DRAFT
SYSTEMATIC PROJECT PLANNING MEMORANDUM
for the
REMEDIAL INVESTIGATION / FEASIBILITY STUDY
FORT MYERS BOMBING AND GUNNERY RANGE
CHARLOTTE COUNTY, FLORIDA

SYSTEMATIC PLANNING MEETING MINUTES

Meeting Date / Time 27 February 2019 at 0900-1200 ET

EXAMPLE OF VSP ANOMALY DENSITY MAP (FOR ILLUSTRATION PURPOSES ONLY)

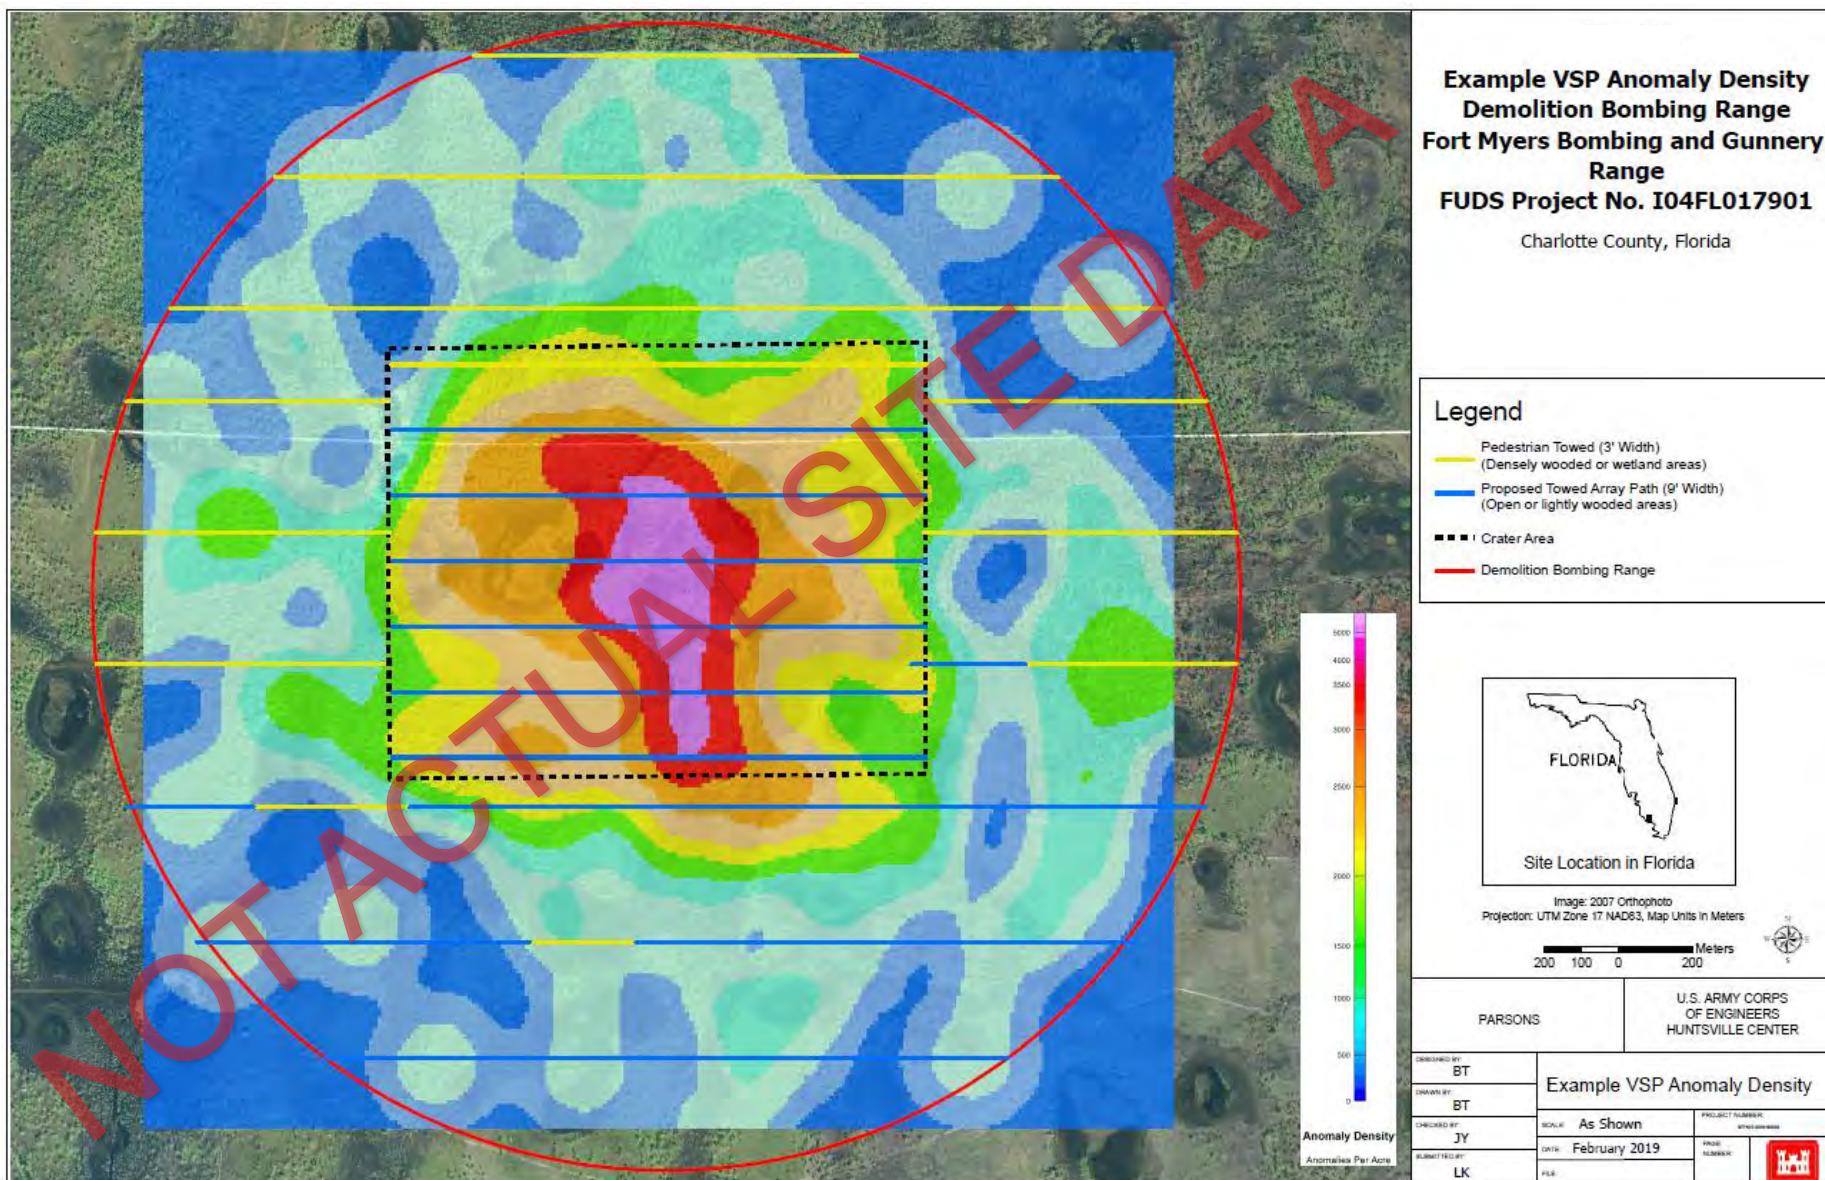
- Slide 43 – Barry Hodges expressed concern about the presentation of the anomaly density heat map on the slide. He indicated that even though it says it is an example that in the future someone might take this slide out of context and assume it is actual site data. Parsons agreed to add an additional watermark behind the anomaly density data.
